11 October 2013

Our Ref: 213.164L3

**RE: DEVELOPMENT APPLICATION No.197/2013 - PROPOSED
RESIDENTIAL AGED CARE FACILITY AT 65-71 ST ALBANS STREET,
ABBOTSFORD**

Figure 1: Location of Proposed Replacement Street Trees in St Albans road reserve – extract from sketch by Umbaco date 9 October 2013

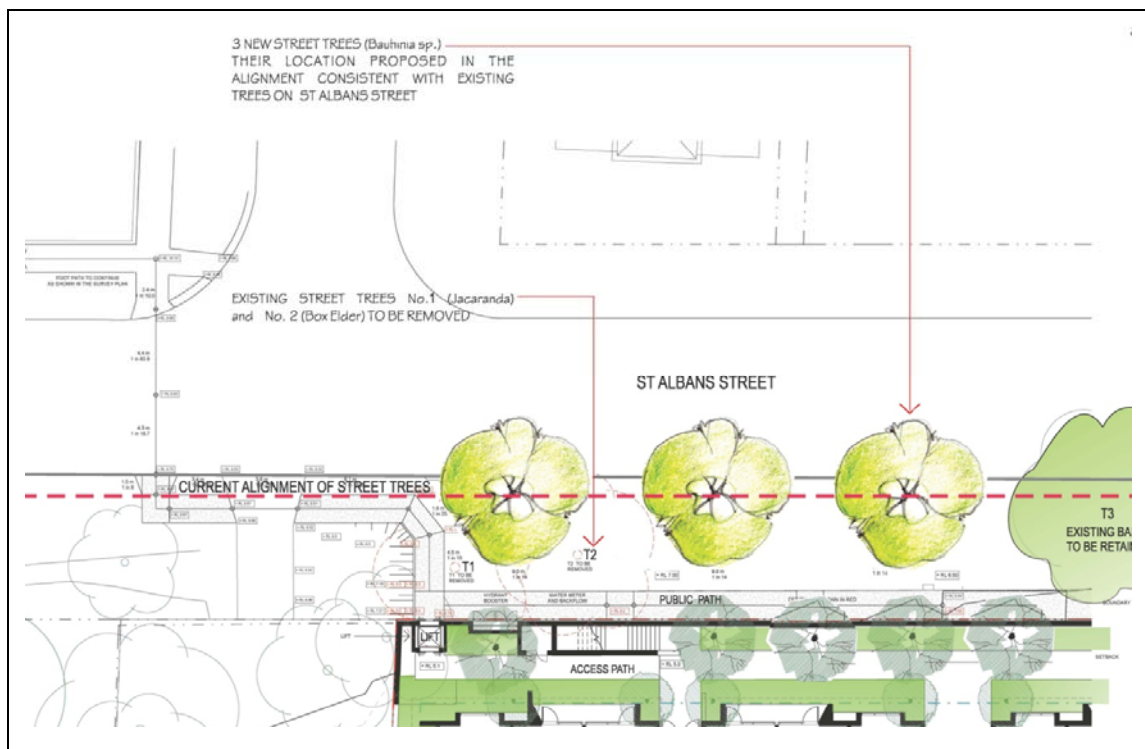
- *An existing established Jacaranda tree will need to be removed;*

The applicant has carefully considered Council's concerns. **Three** new trees will replace the two trees that are to be removed as a result of the pathway realignment. Those new trees will be located so as to be consistent with the other street trees along St Albans Street and as detailed in the sketch prepared by Umbaco dated 9 October 2013 attached at **Appendix A. Figure 1** as follows is an extract from this sketch.

The street trees to be removed in the road reserve in St Albans Street as a result of the reinstatement of the proposed regraded footpath are to be replaced by three (3) new trees in an alignment in accordance with the details shown in sketch prepared by Umbaco dated 9 October 2013. Details of which are to be shown in a detailed landscape plan which is to form part of the relevant Construction Certificate.

Figure 2: Section taken through proposed regraded footpath

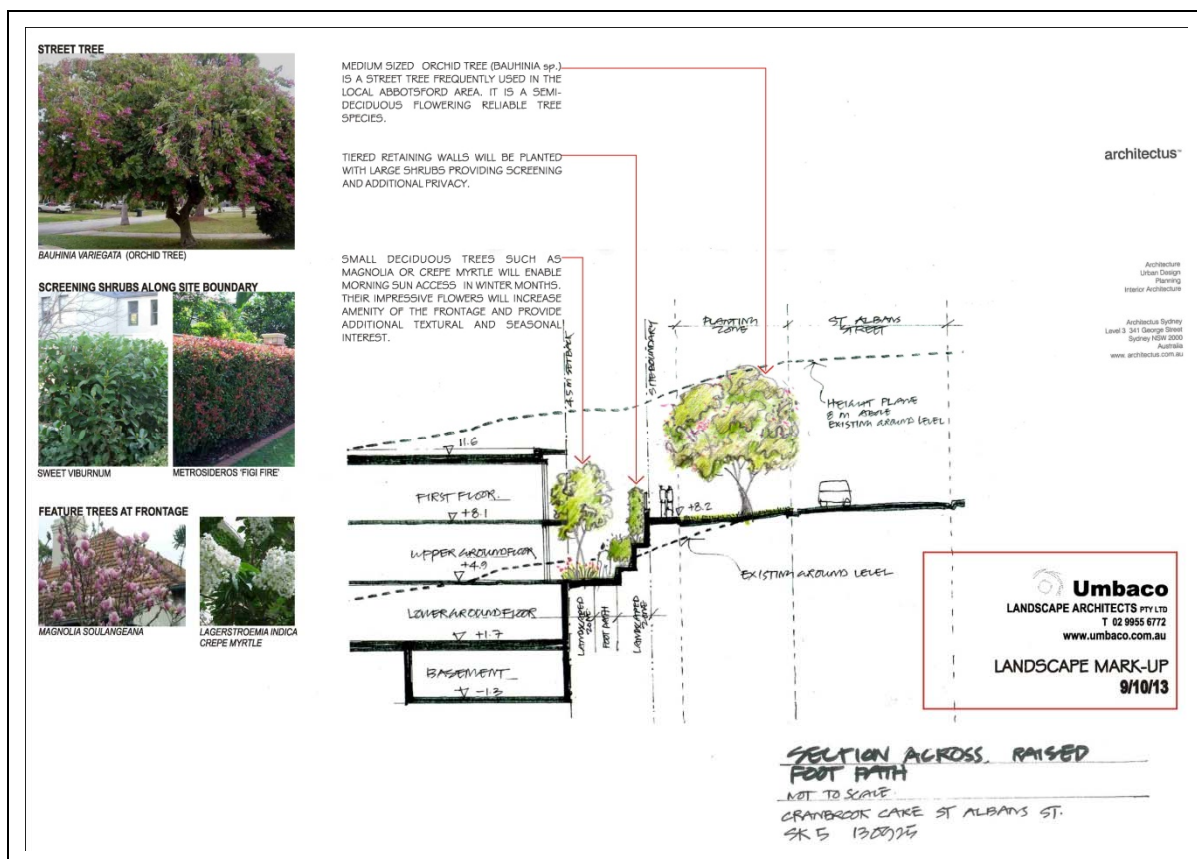
- *The extent of fill would require significant retaining walls which would have a detrimental impact on the existing streetscape;*

The proposed regraded footpath has also been considered in terms of the design of the proposed development and its setback to the boundary at the St Albans property boundary as shown in Figure 2 as follows:

This section demonstrates the landscape treatment along the St Albans Street boundary which is sympathetic to and improves the St Albans streetscape. This sketch information is included at **Appendix A**.

Figure 3: Roof adjustments over entrance and stair exits to St Albans Street

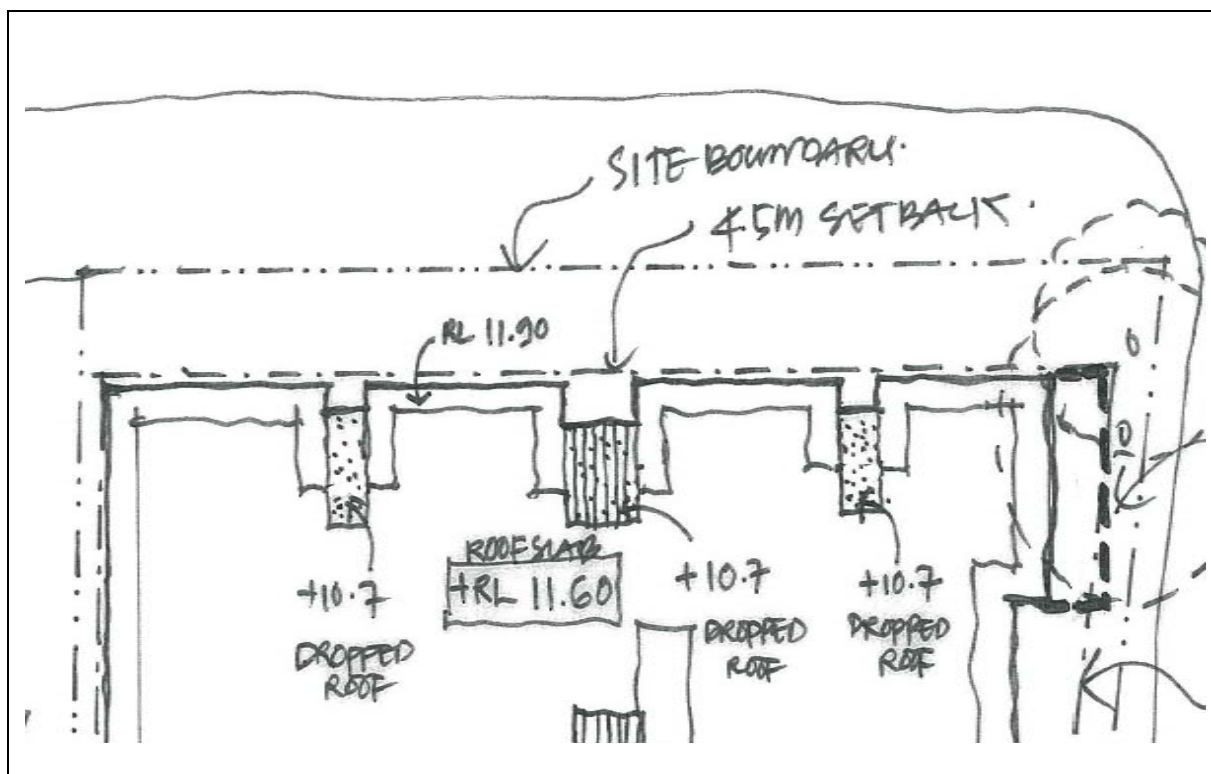
Subclause (c) requires development to maintain neighbourhood amenity and appropriate residential character by providing building setbacks to reduce bulk and overshadowing, using building form and sitting that relates to the site's land form, and adopting building heights at the street frontage that are compatible in scale with adjacent development. Subclause (f) also promotes the retention of major trees wherever reasonable.

So as to reinforce the definition and articulation of the proposed aged care facility development along the St Albans Street frontage, the applicant has incorporated a GM Urban Design proposal for the design of the building to be adjusted over the main entry and the stairs exits so as to include a step to lower the roof line (i.e. the roof element being dropped slightly over the main entry and the stair exits). This adjustment will assist in demonstrating the proposed development is consistent with the planning principles.

This adjustment is demonstrated in the sketch in **Figure 3** below as follows:

Figure 5: Adjusted basement to achieve TPZs for trees #43, #44 and #48

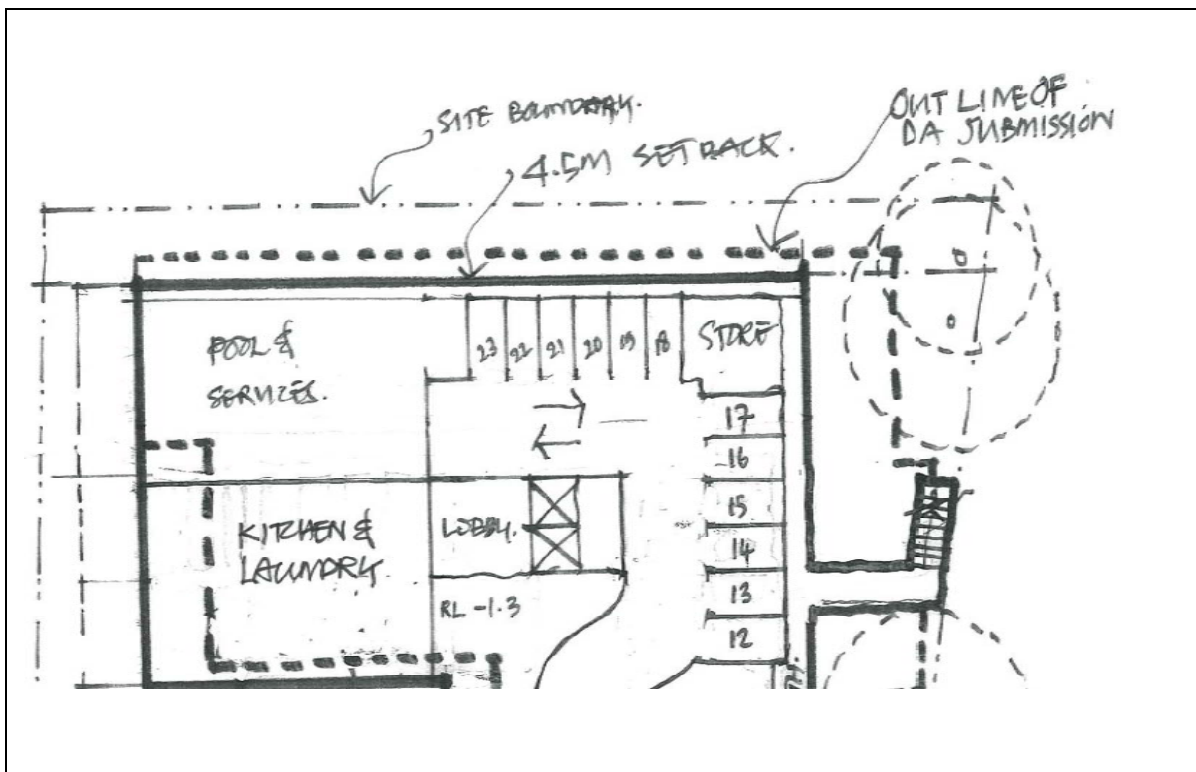
After extensive consultation, design changes have also been made to address Council concerns and to accommodate the AS4970 Tree Protection Zone (TPZ) for this specimen. The previous design had a significant encroachment into the TPZ of this tree however, the changes to the basement and lower ground floor plans now mean that the basement and lower ground floor areas are no longer within the TPZ. The TPZ of this tree is larger than that stipulated by the Australian Standard and as such the tree will be able to be retained in its current healthy state provided it is protected prior to and during construction.

As such, it is considered that to accommodate the TPZs for Trees #43, #44 and #48, a minor adjustment to the design of the buildings can be achieved. The sketch below identifies the minor adjustments in the basement:

Figure 6: Adjusted lower ground level as suggested by Ms Morrish

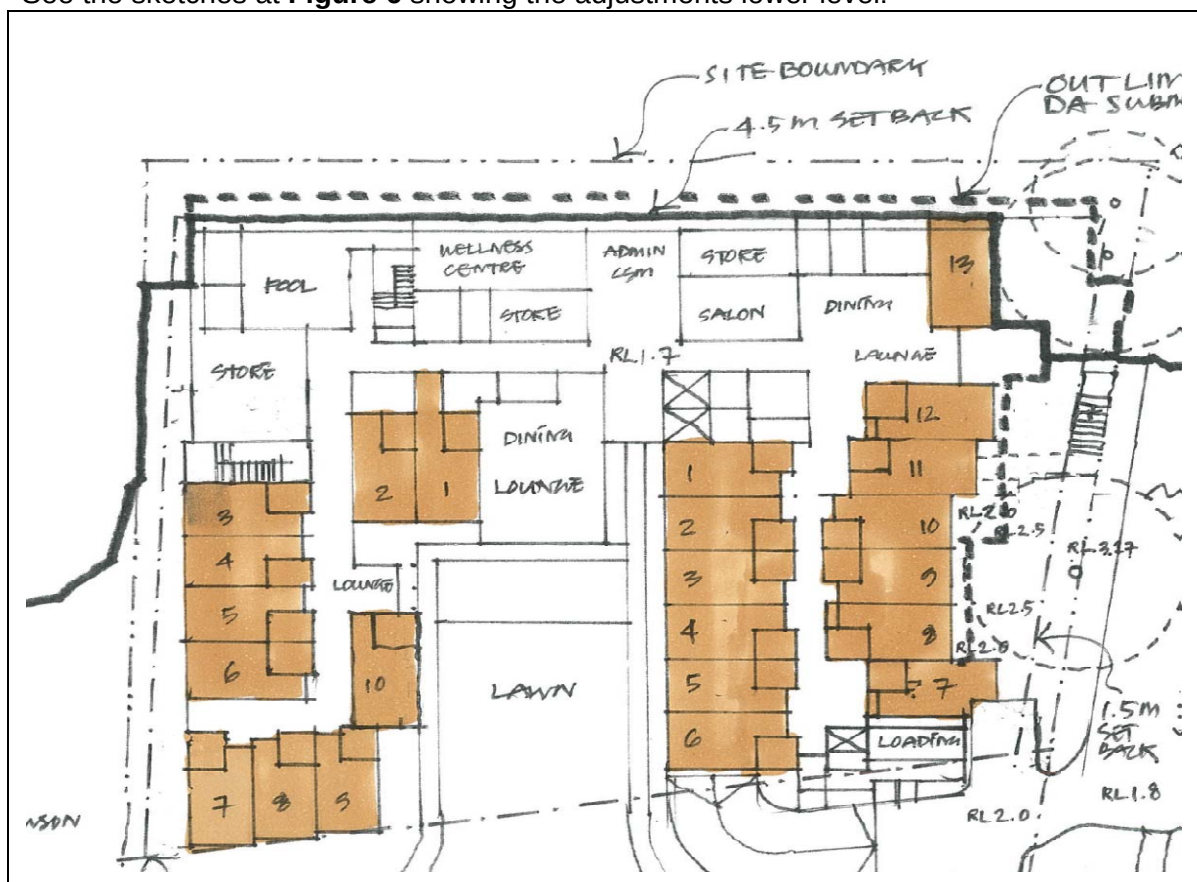
A similar situation is identified to the southern component of the building to this level which is understood to provide for dementia patients and is separated to a certain degree from other components of the facility. The primary area of open space for this dementia unit, being the courtyard, sits over 3m below the Charlton Street verge (not including boundary fencing).

Internal adjustments have been made so that the bedrooms located adjacent to the rock face of the park have been relocated away from this location. Those bedrooms now are located to ensure an outlook and improved amenity. Further, the balconies have also been removed to address Council's concerns.

See the sketches at **Figure 6** showing the adjustments lower level:

Figure 7: Adjusted basement level as suggested by Mr Rogers

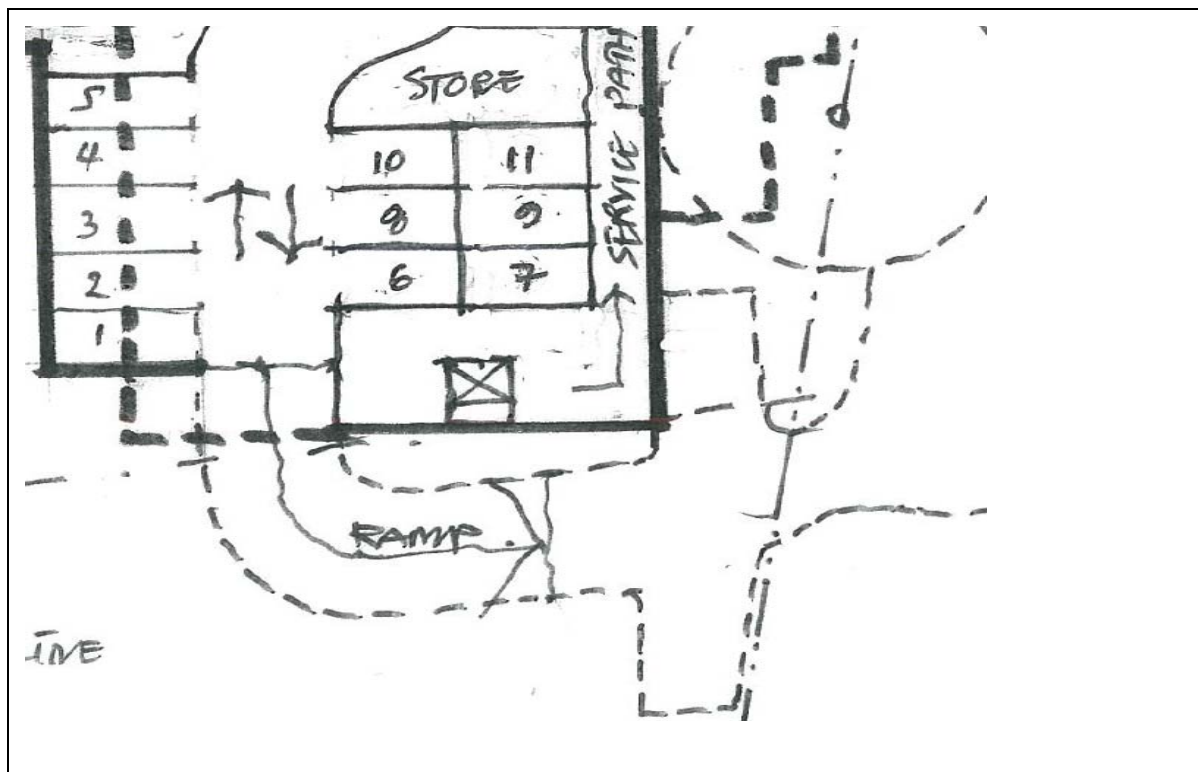
It is noted that Council commissioned Traffix to provide feedback with respect to the DA. The matters raised by Mr Pindar in the Traffix letter have now been addressed by Mr Tim Rogers from Colston Budd Hunt and Kafes in the response which can be found at **Appendix E**.

The response from Mr Rogers includes a suggestion to adjust the location to access the basement car parking and provide for a two-way movement, separate the loading dock from the ambulance bay and adjust the parking layout to accommodate 23 cars as shown in **Figure 7** as follows:

Revised plans are to be prepared prior to the issue of a Construction Certificate showing vehicular access from Charlton Street in accordance with the sketches included in the Colston Budd Hunt and Kafes letter dated 30 September 2013, which provides for a six (6) metre wide driveway with passing opportunities to address the potential for on-street queuing.

Landscape Plan Mark Up Sketch
indicating location of replacement four *Eucalyptus citriodora* (Lemon Scented Gum).

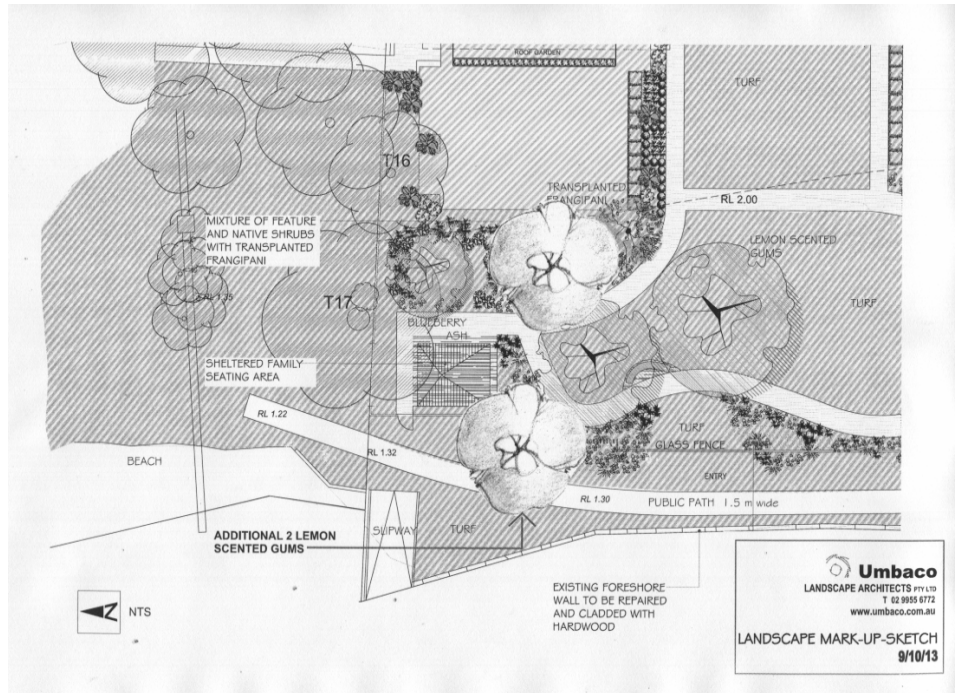
Its retention and provision of an adequate TPZ would also effectively sterilise a large proportion of the Charlton Street frontage from development. An access point to the car park and service areas is required in the Charlton St frontage and given the site constraints it is proposed to remove this tree.

It is proposed to be replaced during landscaping with another two *Eucalyptus citriodora* which are also to be located in the rear garden near the foreshore as indicated in the Landscape Plan below showing a total of four replacement trees. The tree will be replaced with the identical species to maintain the canopy cover from the medium term onwards.
